Access Compliance Report

Public Rights-of-Way

(Curb Ramps)

Intersection ID: 15055	Main Street: BUCHANAN_ST	Cross Street: SCOTT_AV	Location: W
ADA ID: 41961C6B2885	Ramp Type: Directional1	Initial Pass/Fail: Fail	Overall Compliance: No
Severity Score: 13.75			
Codes/Mitigation Info/Possible Solution		Field Measurements/Component Compliance

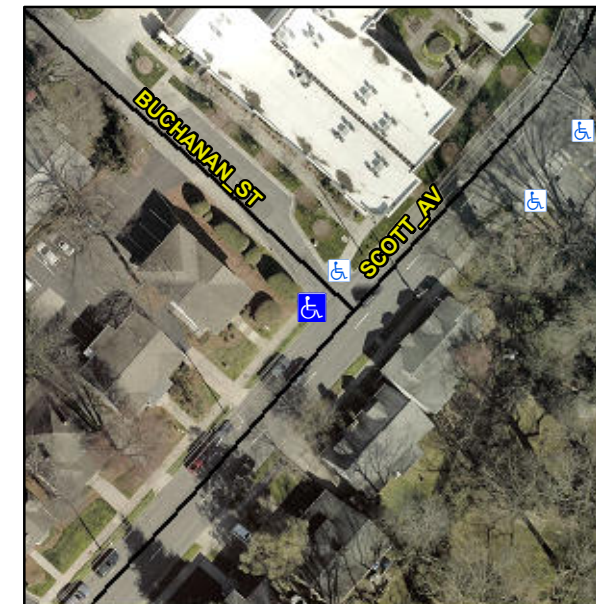
R304.2.2, R304.5.3

Compliance	Description	Data	Compliance	Description	Data
N/A	Ramp Length (in)	84.0	N/A	Grade Break?	N/A
Yes	Ramp Width (in)	48.0	N/A	Grade Break Slope (%)	0.0
No	Ramp Slope (%)	8.4	N/A	Grade Break XSlope (%)	0.0
No	Ramp XSlope (%)	2.1			
N/A	Flare Type LT	N/A	N/A	Flare Type RT	N/A
N/A	Flare Slope LT (%)	N/A	N/A	Flare Slope RT (%)	0.0
N/A	Flare Traversable LT?	N/A	N/A	Flare Traversable RT?	N/A
N/A	Landing Length (in)	0.0	N/A	DWS Provided?	N/A
N/A	Landing Width (in)	0.0	N/A	DWS Contrast?	N/A
N/A	Landing Slope (%)	0.0	N/A	DWS Length (in)	N/A
N/A	Landing X Slope (%)	0.0	N/A	DWS Full Width?	N/A
N/A	Landing Curb? (Y/N)	N/A	N/A	DWS Offset LT (in)	N/A
N/A	Shared Landing?	N/A	N/A	DWS Offset RT (in)	N/A
N/A	Gutter Ponding?	0.0	N/A	Gutter Slope (%)	N/A
N/A	Gutter Lip Ht (in)	0.0	N/A	Gutter X Slope (%)	N/A
N/A	Painted X Walk1?	No		Road Slope (%)	0.6
	X Walk 1 Direction	To NE		Road X Slope (%)	1.6
	X Walk 1 Width (in)	N/A		Clear Space?	N/A

X Walk 1 Slope (%)	0.6	N/A	Clear Space to XWalk (in)	N/A
	X Walk 1 X Slope (%)	1.6	N/A	Storm Grate/Utility Hazard?	N/A
N/A	Ramp inside XWalk1?	N/A		Storm Grate/Utility Type	
N/A	Any Obstructions?	N/A			N/A
	Obstruction Type		Yes	Surface Condition? (G/P)	Good
			N/A	Curb Slope (%)	8.8

Remove & Replace Entire Ramp.
